Access Compliance Report

Public Rights-of-Way

(Curb Ramps)

Intersection ID: 31848	Main Street: RUGGED_STONE_WY	Cross Street: TIBBLE_CREEK_WY	Location: SW
ADA ID: 70644727223D	Ramp Type: PerpDiag	Initial Pass/Fail: Fail	Overall Compliance: No
		Severity Score: 12.5

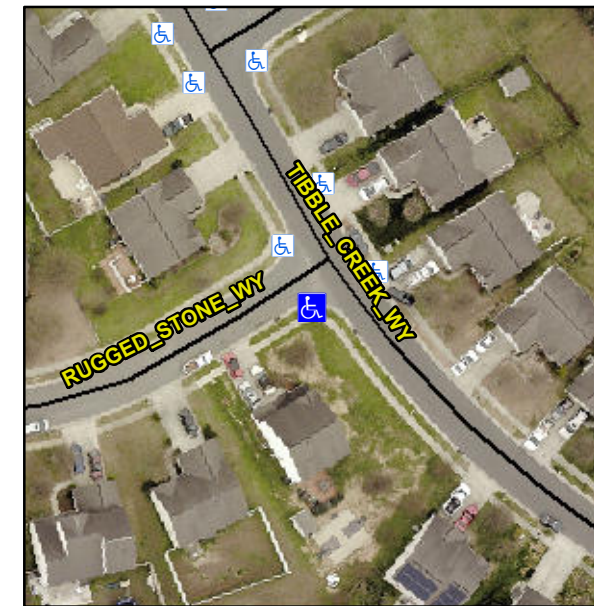
Not Found, R304.2.2

Compliance	Description	Data	Compliance	Description	Data
N/A	Ramp Length (in)	45.0	No	Ramp Slope (%)	10.5
Yes	Ramp Width (in)	51.0	Yes	Ramp XSlope (%)	0.0
N/A	Flare Type LT	N/A	N/A	Flare Type RT	N/A
N/A	Flare Slope LT (%)	N/A	N/A	Flare Slope RT (%)	N/A
N/A	Flare Traversable LT?	N/A	N/A	Flare Traversable RT?	N/A
N/A	Landing Length (in)	N/A	N/A	DWS Provided?	N/A
N/A	Landing Width (in)	N/A	N/A	DWS Contrast?	N/A
N/A	Landing Slope (%)	N/A	N/A	DWS Length (in)	N/A
N/A	Landing X Slope (%)	N/A	N/A	DWS Full Width?	N/A
N/A	Landing Curb? (Y/N)	N/A	N/A	DWS Offset (in)	N/A
N/A	Shared Landing?	N/A			
N/A	Gutter Ponding?	N/A	N/A	Gutter Slope (%)	N/A
N/A	Gutter Lip Ht (in)	N/A	N/A	Gutter X Slope (%)	N/A
N/A	Painted X Walk1?	No	N/A	Painted X Walk2?	No
	X Walk 1 Direction	To NE		X Walk 2 Direction	To NW
N/A	X Walk 1 Width (in)	N/A	N/A	X Walk 2 Width (in)	N/A
	X Walk 1 Slope (%)	0.9		X Walk 2 Slope (%)	1.5
	X Walk 1 X Slope (%)	0.3		X Walk 2 X Slope (%)	1.1

Remove & Replace Curb Ramp With Two New Directional Ramps or Equivalent.
